**Minutes – Appeal Committee – April 20, 2026**

**Item No. 2 Appeal – Variance – 595 Gertrude Avenue**
**(Fort Rouge-East Fort Garry Ward)**
**File DAV 262234A/2025B**

# THE CITY OF WINNIPEG
# VARIANCE APPEAL ORDER
## APPEAL COMMITTEE

**Title:** DAV 25-262234\B – 595 Gertrude Ave

**Figure 4: Fencing along the west property line.**

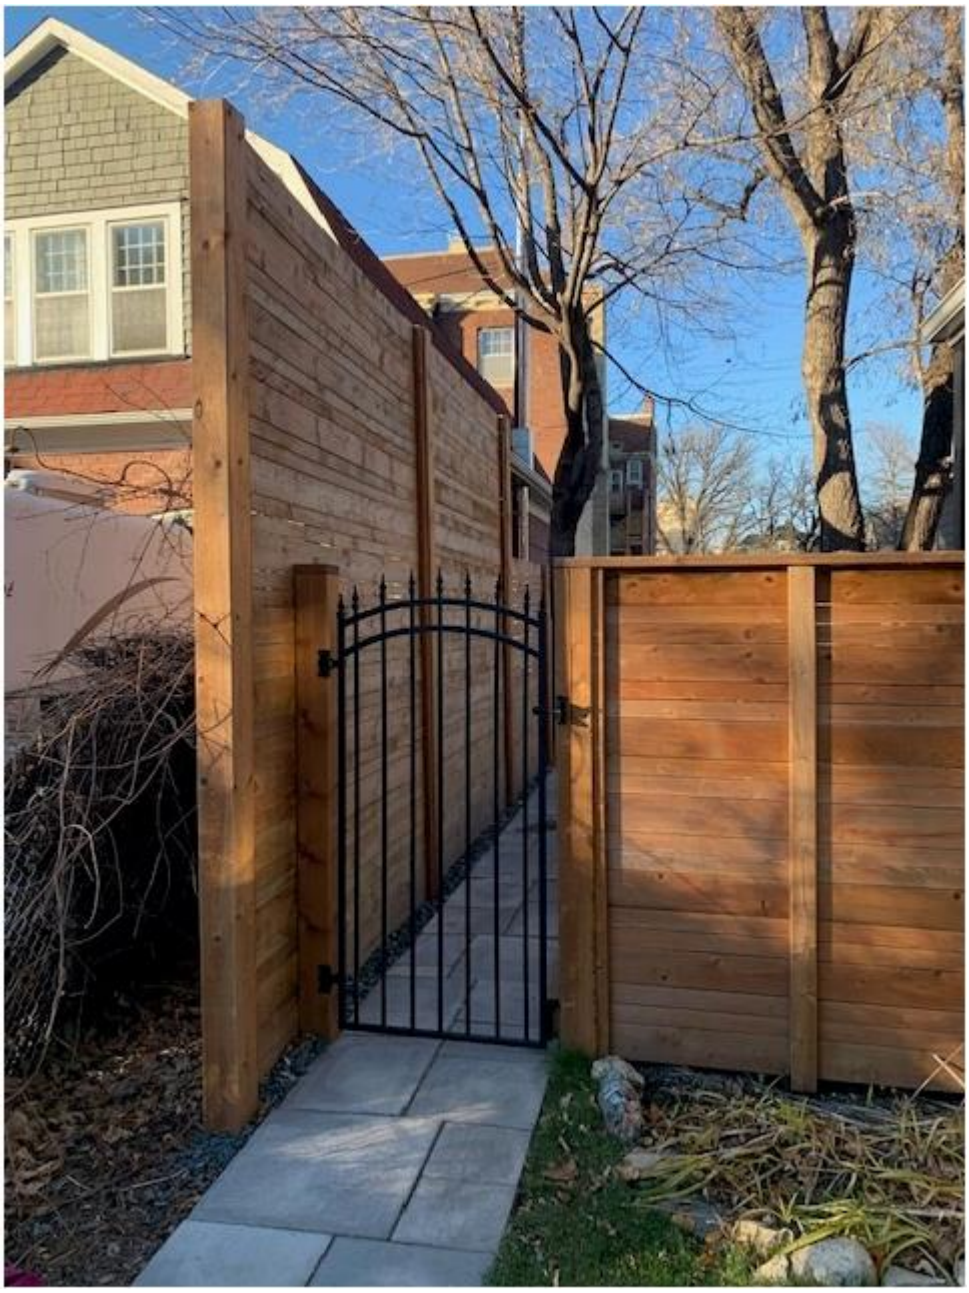
The applicant intends to maintain the existing fence height of 11.3 feet along a portion of the west side yard and a fence height of 8.09 feet along the rear yard. For these reasons, a Variance is required.

The increased height of the existing fencing is not compatible with the dwelling or existing fencing on the block and poses a substantial adverse impact upon adjoining properties and the adjacent area.

The existing fence heights far exceed the by-law regulations and what would be supported by Urban Planning. In 2023, the applicant worked with Urban Planning to arrive at a compromised height of 7.5 feet and the applicant advised that they would reduce the fence height accordingly. Further inspections at the site reveal that the applicant did not complete the necessary reduction to the fence height to meet the supported and approved height of 7.5 feet.

If the applicant feels that they require more privacy than they previously were granted via the Variance order from 2023, they can construct some type of lattice like structure that can then be covered in some type of vegetation, in the buildable area of their property. This option would not require a Variance for height so long as it did not exceed 13 feet.

Sheet Name:
PRIVACY SCREEN
LOCATION LAYOUT

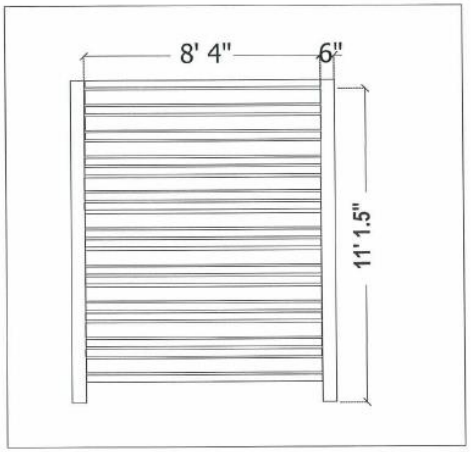
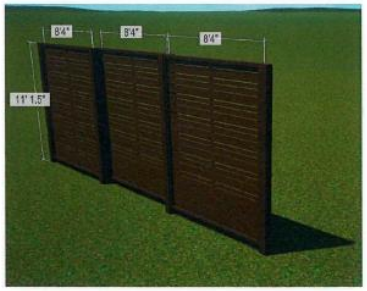
1. The neighbours are supportive. There's a lot of good rationale for why. It isn't 11 feet around the entire permitter; it's 11 feet at a point for a reason. To take it down to put up a lattice-like structure that's 13 feet seems a bit pointless or punitive, frankly. So, the height makes sense, I think, in the community.

1. The neighbours are supportive. There's a lot of good rationale for why. It isn't 11 feet around the entire permitter; it's 11 feet at a point for a reason. To take it down to put up a lattice-like structure that's 13 feet seems a bit pointless or punitive, frankly. So, the height makes sense, I think, in the community.

The fence serves a clear and reasonable privacy function in a dense residential context where neighbouring properties are built in close proximity, with a non-standard alignment of the neighbouring home that results in direct sightlines into our rear yard and their interior living spaces.

Notably, the house immediately to the west is set significantly farther back on its lot, with several windows facing directly into our rear yard from their living room, dining room, kitchen, and den.

These sightlines were previously screened by an older garage structure that had deteriorated and required removal. The increased fence height restores privacy for both properties in approximately the same area previously occupied by the garage and is lower in height than that original structure by several feet.

1. A fence height of 11.13 feet (3.39 metres) in the west side yard
